Addendum: RV-8 70CC Rudder Control Horn Update

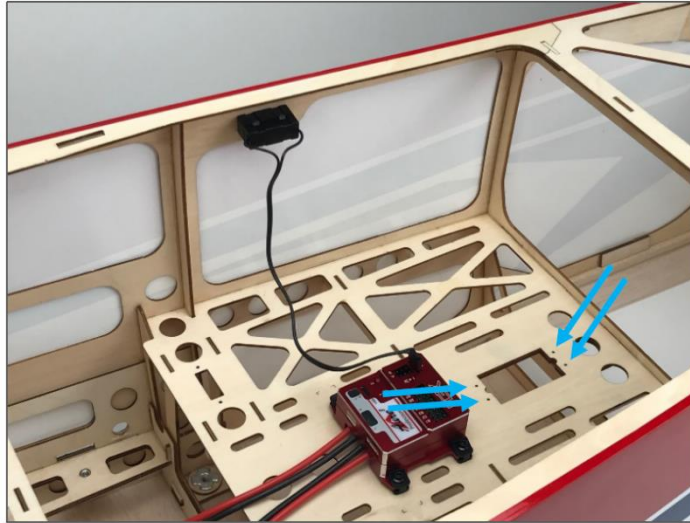
We noted that the description of the control horn markings and the description in the manual is not consistent. Please note the following for clarity regarding the rudder control horns installation:

Option 1: Pull/Pull Installation (4 Control Horns marked “PULL”):

- Install these control horns when the rudder servo is mounted in the fuselage:

-
- Use the four control horns marked “Pull”. Two control horns for the left side and two for the right side. Use a backplate for each set of control horns.
- These control horns should be installed 40mm from the bottom edge of the rudder, as depicted in the image provided:
